# UNITED STATES PATENT AND TRADEMARK OFFICE

APPLICATION NO.	FILING DATE	FIRST NAMED INVENTOR	ATTORNEY DOCKET NO.	CONFIRMATION NO.
10/801,119	03/15/2004	Carsten Neumann	NEUMANN C 1	9186
<div>7590 COLLARD &amp; ROE, P.C. 1077 Northern Boulevard Roslyn, NY 11576-1696</div>			<div>EXAMINER WOODALL, NICHOLAS W</div>	
			<div>ART UNIT 3733</div>	<div>PAPER NUMBER</div>
			<div>MAIL DATE 12/06/2007</div>	<div>DELIVERY MODE PAPER</div>

<b>Office Action Summary</b>	Application No. 10/801,119	Applicant(s) NEUMANN, CARSTEN	
	Examiner Nicholas Woodall	Art Unit 3733

### **DETAILED ACTION**

Figure 1

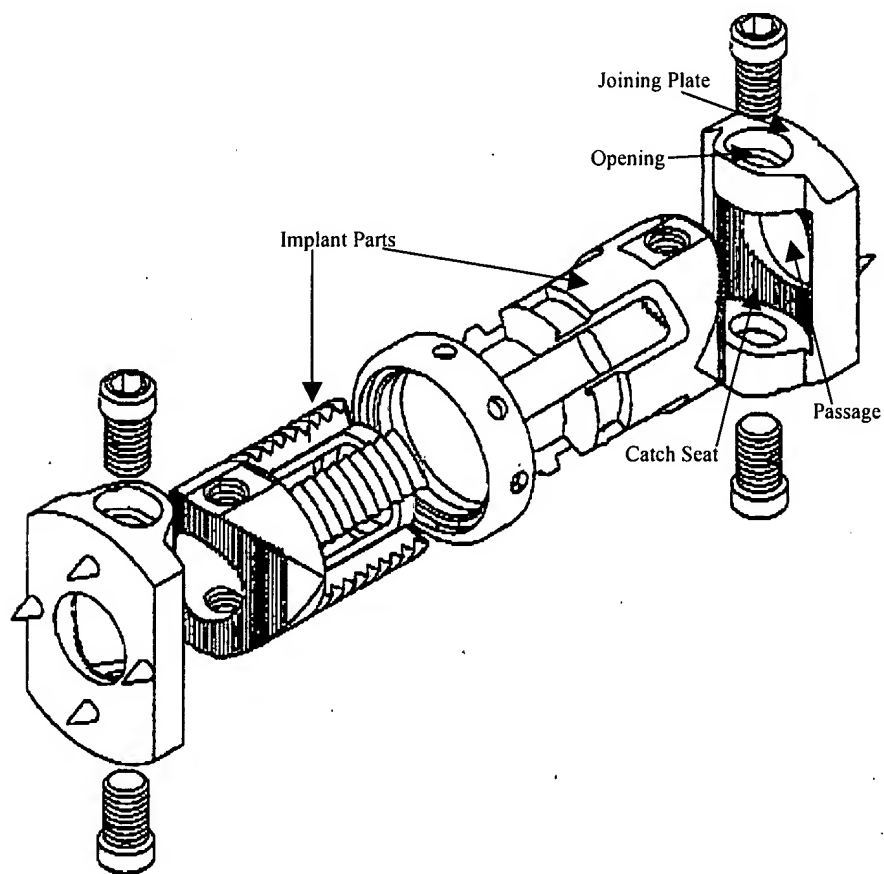
Regarding claim 1, Yeh discloses a device comprising at least two implant parts. The two implant parts comprising a first implant part, a second implant part, and a joining plate that is capable of being releasably connected with an end of the first implant part or the second implant part (see Figure 1 below). The joining plate further includes an opening capable of being used for releasable attachment of the joining plate, wherein the opening is capable of being located outside the center of gravity of the joining plate. The first implant part and the second implant part are axially adjustable relative to each other along the longitudinal axis of the device. Regarding claim 3, Yeh discloses a device wherein the joining plate projects beyond an outside contour of the device. Regarding claim 5, Yeh discloses a device wherein the shape of the opening is capable of being contoured to an outside contour of the device. Regarding claim 9, Yeh discloses a device wherein the joining plate includes a means for attachment and is capable of being attached to at least one of the at least two implant parts. Regarding claim 10, Yeh discloses a device further comprising a catch seat wherein the means for attachment is formed by a plug-in connection between the joining plate and at least one of the two implant parts. Regarding claim 17, Yeh discloses a device wherein the joining plate includes a passage opening. Regarding claim 23, Yeh discloses a device wherein the joining plate has a side that faces the vertebrae and is capable of being inclined relative to the longitudinal axis of the device. Regarding claim 24, Yeh discloses a device wherein the joining plate has a side that faces the at least two implant parts and is capable of being inclined relative to the longitudinal axis of the device.

Regarding claims 2 and 25, Yeh discloses the invention as claimed except for the thickness of the joining plate being between 2% and 30% of the height of at least one of the two implant parts (claim 2) and the joining plate having an angle of incline between 3 degrees and 45 degrees (claim 25). It would have been obvious to one having ordinary skill in the art at the time the invention was made to manufacture the device of Yeh wherein the joining plate has a thickness between 2% and 30% of the height of at least one of the two implant parts and the joining plate having an angle of incline between 3 degrees and 45 degrees, since it has been held that where the general conditions of a claim are disclosed in the prior art, discovering the optimum or workable ranges involves only routine skill in the art. In re Aller, 105 USPQ 233.

Regarding claims 1, 8, and 14-16, Yeh discloses the invention as claimed except for the surface of the joining plate facing a vertebra is convex shaped (claim 8), the joining plate having a polygon shape (claim 14), the joining plate having a rounded shape (claim 15), and the joining plate having a star shape (claim 16). It would have been an obvious matter of design choice to one skilled in the art at the time the invention was made to manufacture the device of Yeh wherein a surface of the joining plate facing a vertebra is convex, the joining plate having a polygon shape, the joining plate having a rounded shape, and the joining plate having a star shape, since applicant has not disclosed that such solve any stated problem or is anything more than one of numerous shapes or configurations a person ordinary skill in the art would find obvious for the purpose of providing a shape of a joining plate. In re Dailey and Eilers, 149 USPQ 47 (1966).

Regarding claim 18, Yeh discloses the invention as claimed except for the joining plate having a plurality of passage openings. It would have been obvious to one having ordinary skill in the art at the time the invention was made to manufacture the device of Yeh wherein the joining plate has a plurality of passage openings, since it has been held that mere duplication of the essential working parts of a device involves only routine skill in the art. *St. Regis Paper Co. v. Bemis Co.*, 193 USPQ 8.

Figure 2

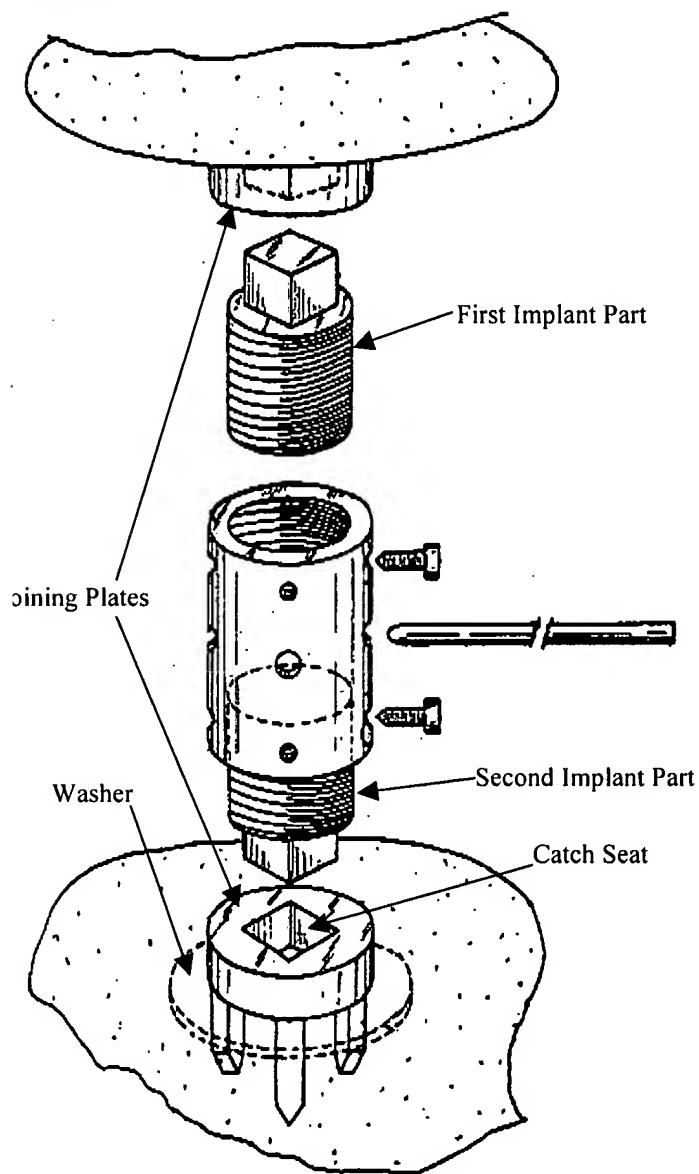
Regarding claim 1, Daher discloses a device comprising at least two implant parts and a joining plate. The at least two implant parts are axially adjustable relative to each other. The joining plate is capable of being releasably connected with a free end with at least one of the two implant parts and is substantially perpendicular relative to the longitudinal axis of the implant (see Figure 2 below). The joining plate further includes an opening capable of being used for releasable attachment of the joining plate, wherein the opening is capable of being located outside the center of gravity of the joining plate. Regarding claim 2, Daher discloses a device wherein the joining plate has a thickness that is between 2% and 30% the height of at least one of the two implant parts. Regarding claim 3, Daher discloses a device wherein the joining plate includes a washer that projects beyond the outside contour of the implant parts. Regarding claim 4, Daher discloses a device further comprising a means for releasable attachment of the joining plate wherein the means is an opening formed in the joining plate. Regarding claim 5, Daher discloses a device wherein the shape of the opening in the joining plate is adapted to the outside contour of the implant parts. Regarding claim 6, Daher discloses a device wherein the opening in the joining plate is positioned in the center of gravity of the joining plate. Regarding claim 9, Daher discloses a device wherein there are two joining plates which have a means for attachment that is an opening in the joining plates that are attached to at least one of the implant parts. Regarding claim 10, Daher discloses a device further comprising a catch seat that is part of the plug-in connection that forms the attachment means between the joining

plate and at least one of the implant parts. Regarding claim 15, Daher discloses a device wherein the joining plate is circular shaped.

Further regarding claim 1, Daher discloses the invention as claimed except for the joining plate having a star shape. It would have been an obvious matter of design choice to one skilled in the art at the time the invention was made to manufacture the device of Daher wherein the joining plate having a star shape, since applicant has not disclosed that such solve any stated problem or is anything more than one of numerous shapes or configurations a person ordinary skill in the art would find obvious for the purpose of providing a shape of a joining plate. In re Dailey and Eilers, 149 USPQ 47 (1966).
